TOWN OF KITTERY

ITEM 2—5 Whipple Road—Major Site Plan — Final Review

OVERALL SITE PLAN
 MAINE MEAT BUTCHER & RESTAURANT
 5 WHIPPLE ROAD, KITTEERY, MAINE

SCALE: 1" = 20'	APPROVED BY: MJS	DRAWN BY: MJS
DATE: 01/30/24	REVISION DATE: A : 03/22/24	
JOB NO: 23088	FILE: 5 WHIPPLE BASE.DWG	SHEET: 8

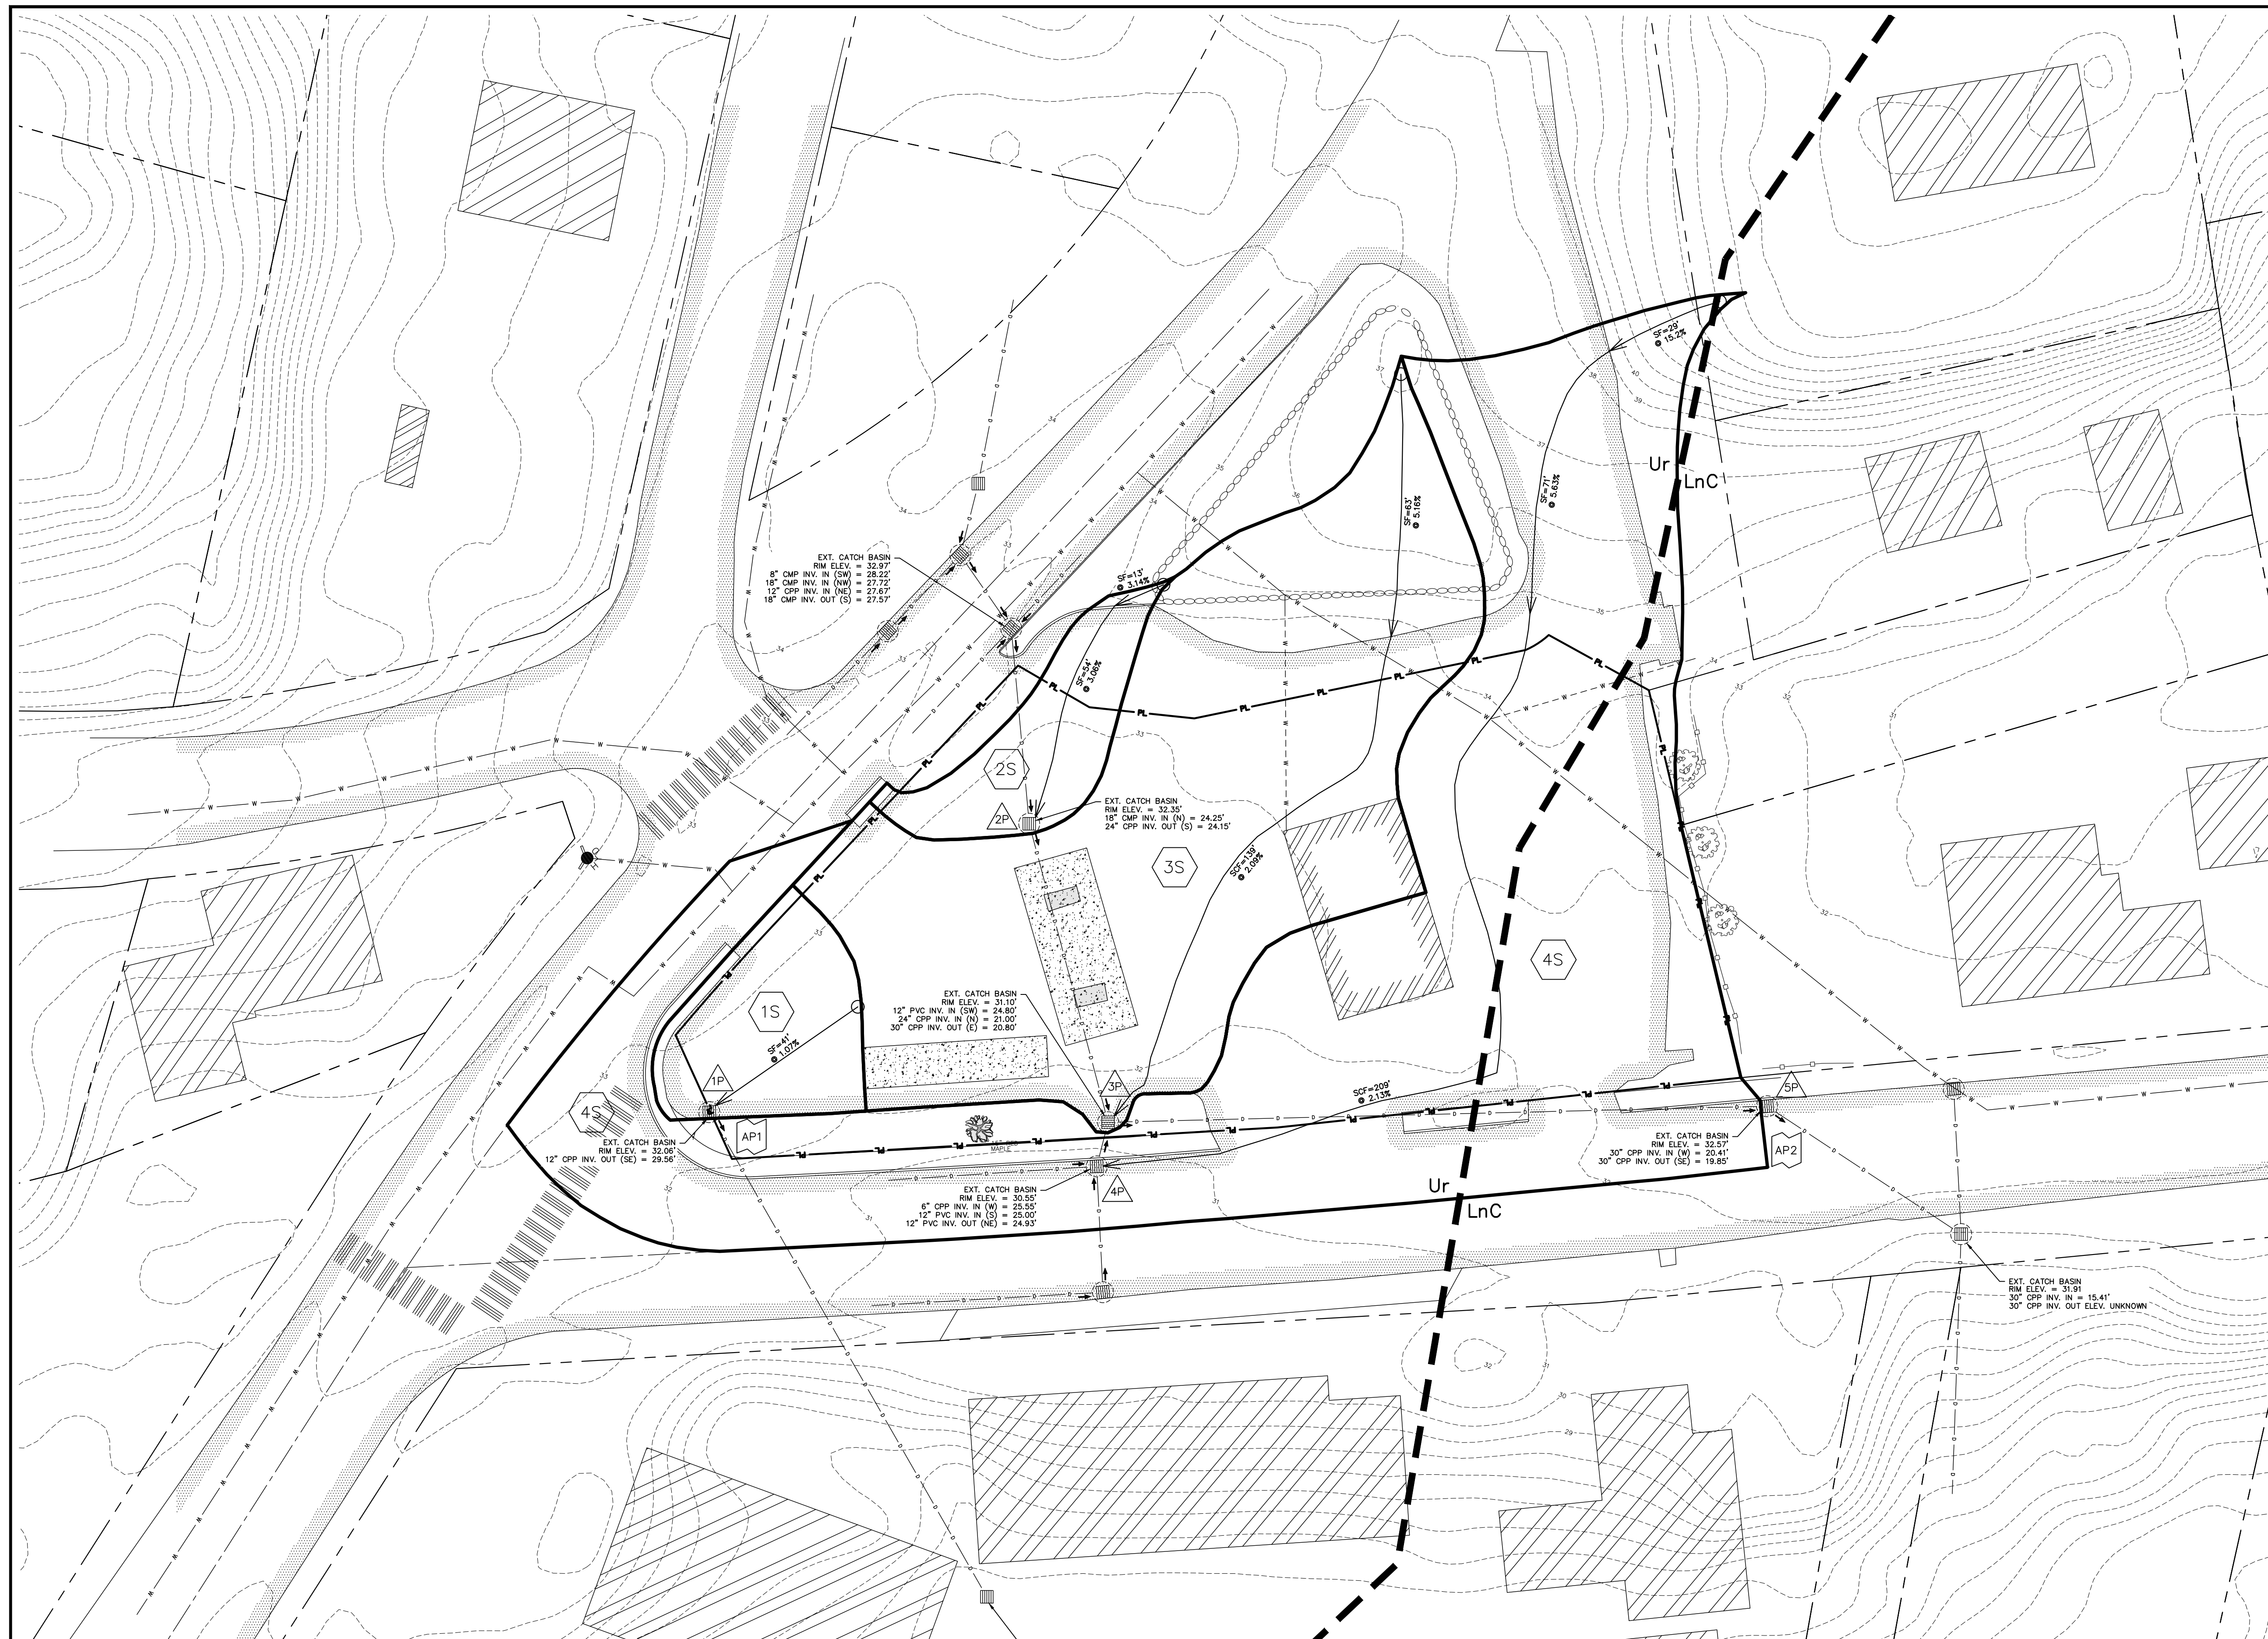
- Sheets #8 (Stormwater: Existing Condition) and #9 (Stormwater: Developed Condition) have been revised to include rim and invert elevations of the downstream structures used as analysis points in the stormwater model.
